# Public Hearing Staff Analysis
# CZ-6-2024
# 319 N. Generals Blvd.

# LINCOLNTON RETAIL

# REZONING PLAN

**RZ-1**
Sheet 1 of 3

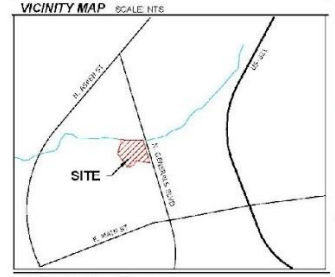
6. Any newly planted trees for landscaping or screening cannot be located under utility lines.
7. The ordinance requires 512 parking spaces, but the plan shows 496. The City will agree to 496 spaces; however, the plan will need to show the parking space dimensions meeting the ordinance requirements.

10. Need Water Supply Watershed Calculations provided on the plan equal to less than 70%.

11. Parking Lot landscaping breakdown showing required landscaping including 50% interior requirements
12. The landscape plan shows the ordinance requirements for street trees; however, the screening requirements would need to be met in the portion across from any residential lots.
13. The location of dumpsters and HVAC/mechanical equipment needs to be shown on the plan, as well as the screening for those items.

**RZ-3**
Sheet 3 of 3

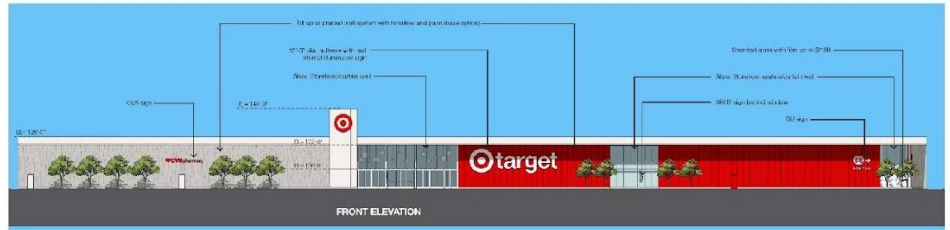
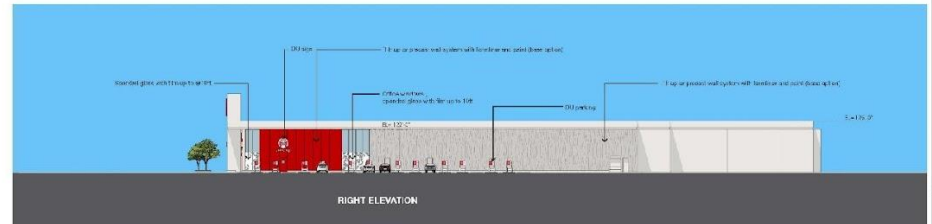
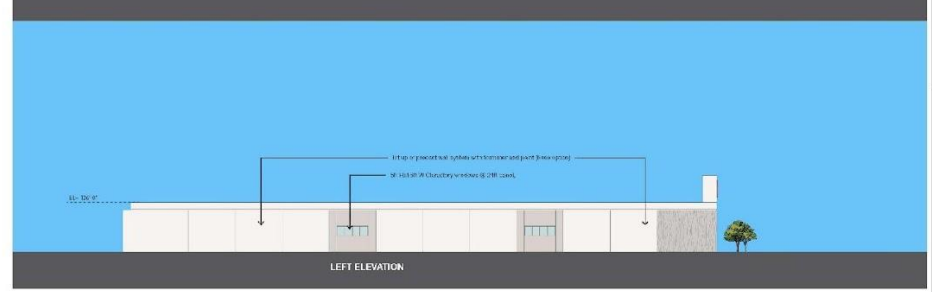
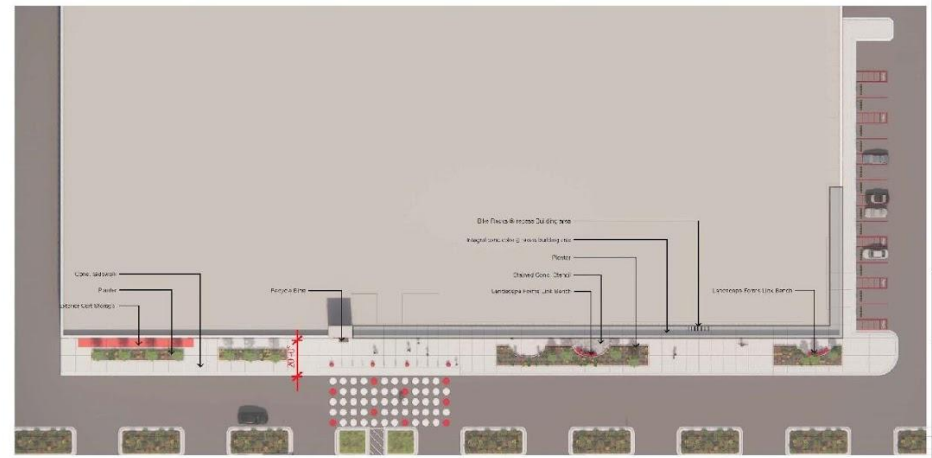
3. Building plans must be submitted and approved by Lincoln County Inspection prior to development.
4. Development on the site is to be consistent with the above site plan and architectural renderings. Must meet architectural requirements CC District.
